Proposed Change 1772

Code Reference(s):	NBC20 Div.B 3.4.6.5. (first printing)
Subject:	Other — Use and Egress
Title:	Minimum Width of Stairs or Ramps Between Handrails
Description:	This proposed change clarifies the minimum width of stairs or ramps where an intermediate handrail is required.
Related Code Change Request(s):	CCR 1546

Figure [A-3.4.6.5.(3)-A]
Stair where an intermediate handrail is not required by Clause 3.4.6.5.(3)(a)

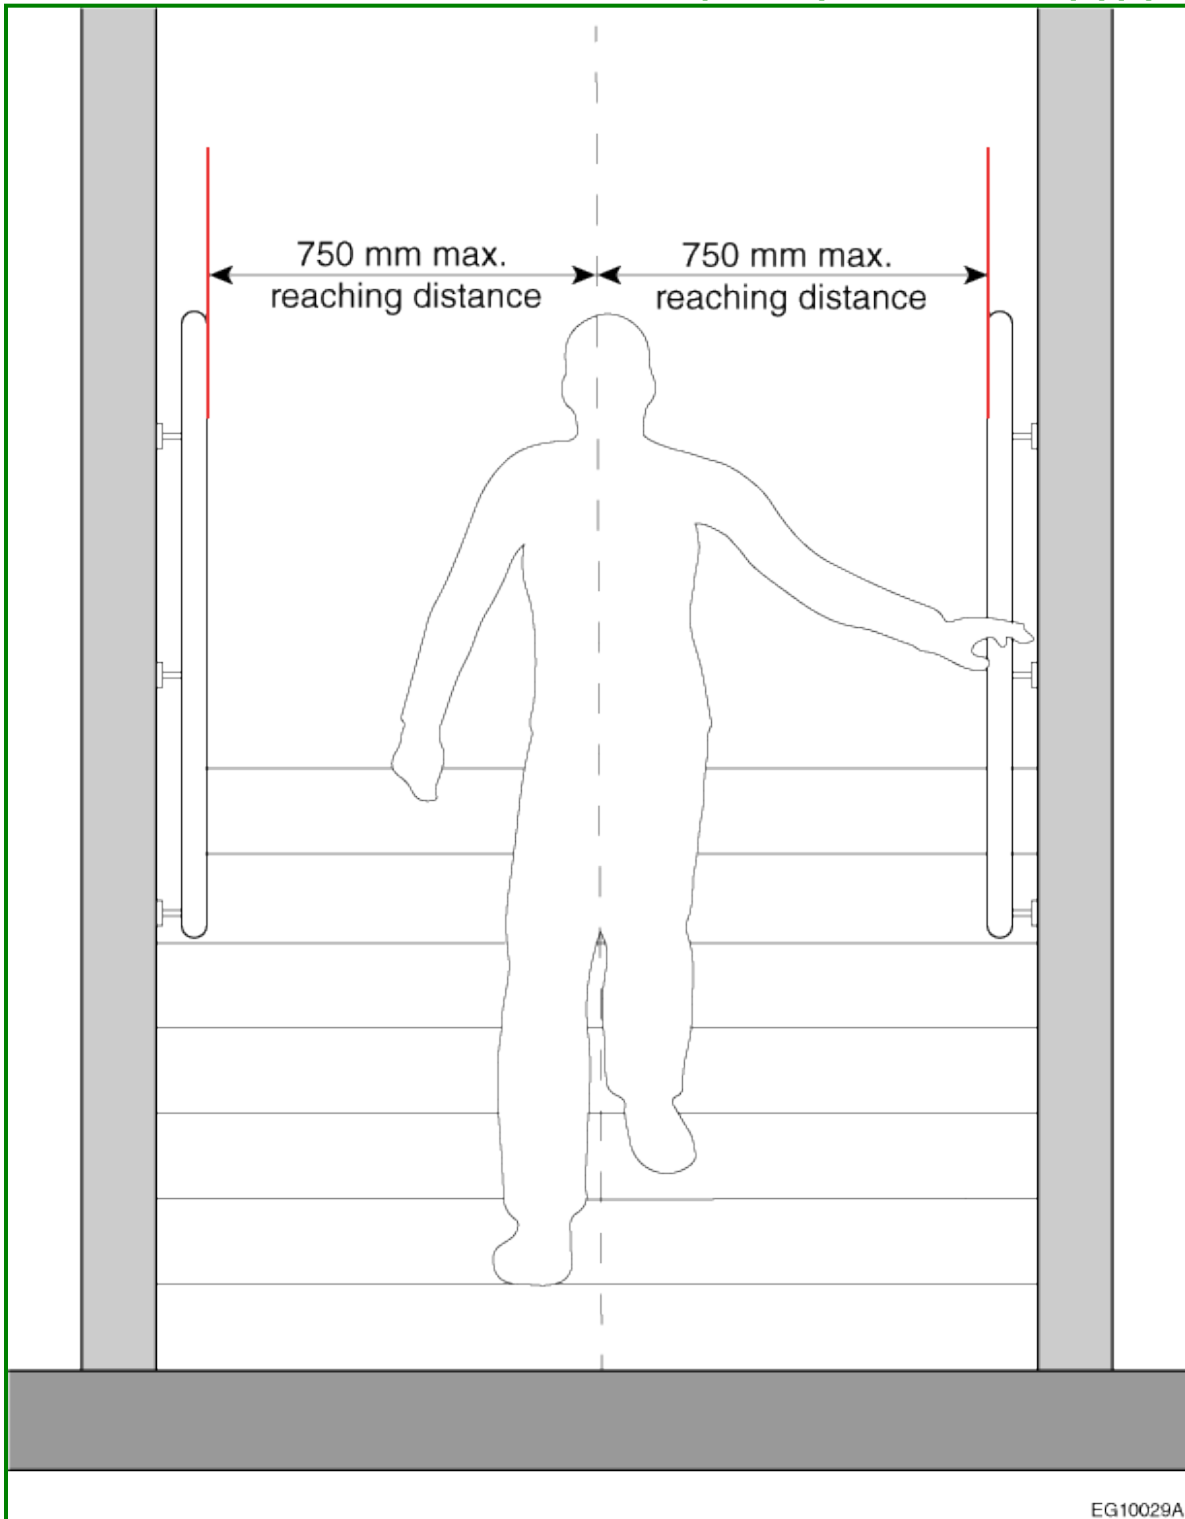
This proposed change also introduces explanatory Note A-3.4.6.5.(3) to clarify where the intermediate handrail is required by Sentence 3.4.6.5.(3) and how to measure the relevant dimensions. Additionally, two figures are provided to illustrate where an intermediate handrail is not required and where a handrail is required.

Where a stair or ramp is too wide for this reaching distance to be satisfied with handrails at the sides of the stair or ramp, an intermediate handrail is required. Clause 3.4.6.5.(3)(b) establishes that an intermediate handrail must be provided so that at least one portion of the stair or ramp has at least the minimum width required for stairs and ramps (often 1 100 mm) in order to accommodate the flow of two lines of occupants in an emergency.

Clause 3.4.6.5.(3)(a) establishes that a handrail must be provided within arm's reach (750 mm) of any location in the portion of a stair or ramp that contains the required exit width, in order to mitigate the risk of injury due to missteps and falls. This 750 mm distance should be measured to the nearest edge of the handrail.

Clause 3.4.6.5.(3)(c) establishes that all other portions of a stair or ramp must have a clear width between handrails of at least 510 mm.
